DATE: January 23, 2025
TO: Blue Bird Owners
Subject: R24CX: Ametek MUX Firmware

NHTSA Number: 24V-068 (School Bus)

SUBJECT: R24CX: Ametek MUX Firmware

R24CX: Ametek MUX Firmware

Multiplex Module (Blue Bird Part # 10059122) Shown Below, As Reference Only

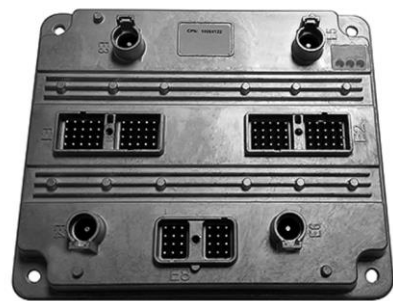
Corrective Action: Both software files (Application & Simulink) in the A-zone, C-zone, and D-zone MUX/PMM modules need to be updated.

- Application version 1.4 or greater
- Simulink 2-3-3 or greater

Figure 2

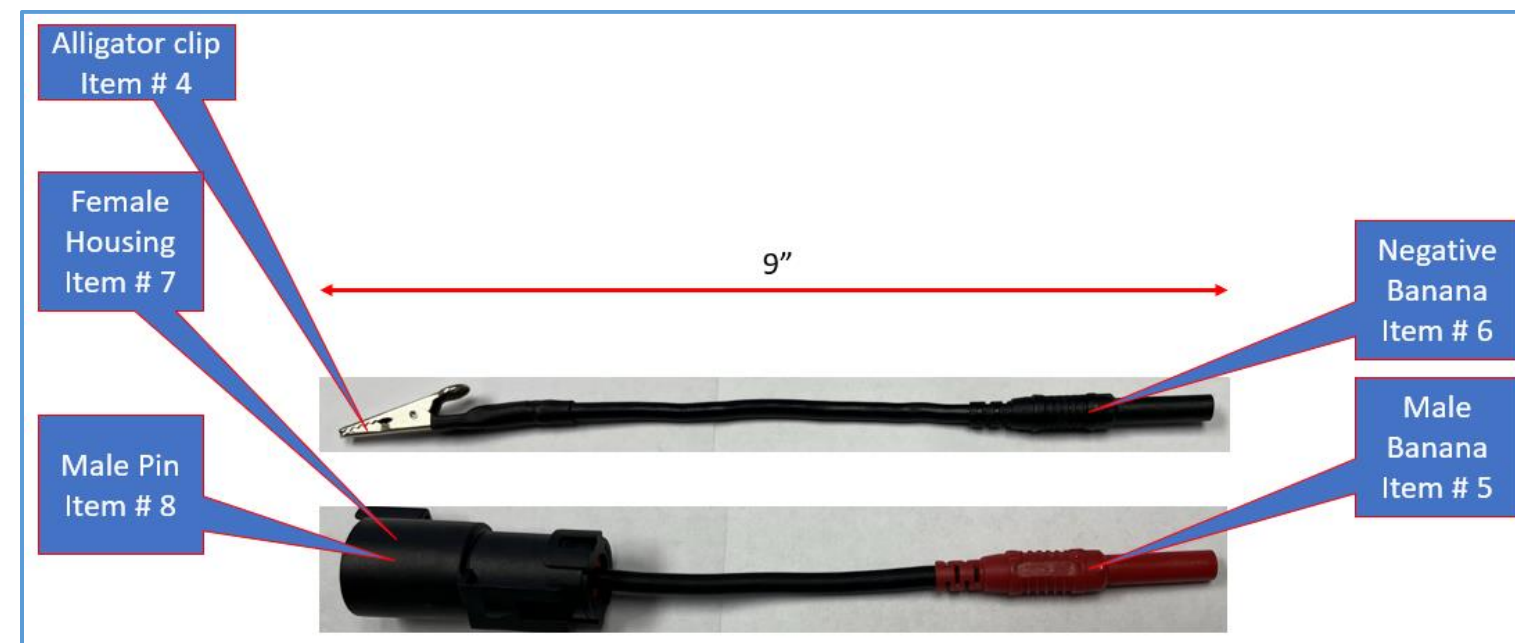
- Optional: Bench harness power/ground jumpers can be fabricated per FIG 2.

Figure 1

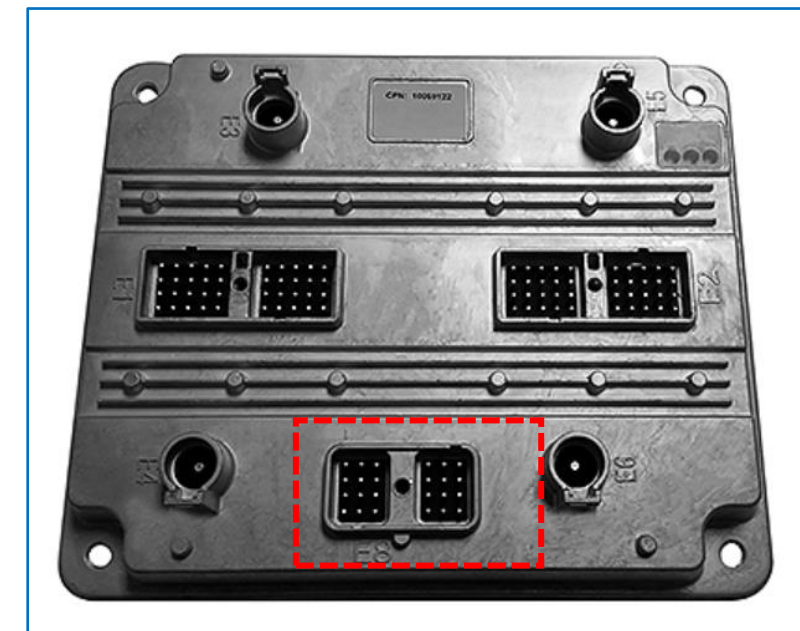
Step 3: Disconnect the E8 connector off each PMM with 4mm Allen wrench. Figure 1

Step 9: Re-install all E8 connectors starting with A zone first, then C, then D. Torque fastener to 25-28 IN-LB (2.82-3.13 Nm)

Note: Do not use power tools to install E8 connector. This securement bolt is sacrificial to prevent over torque and will snap off.
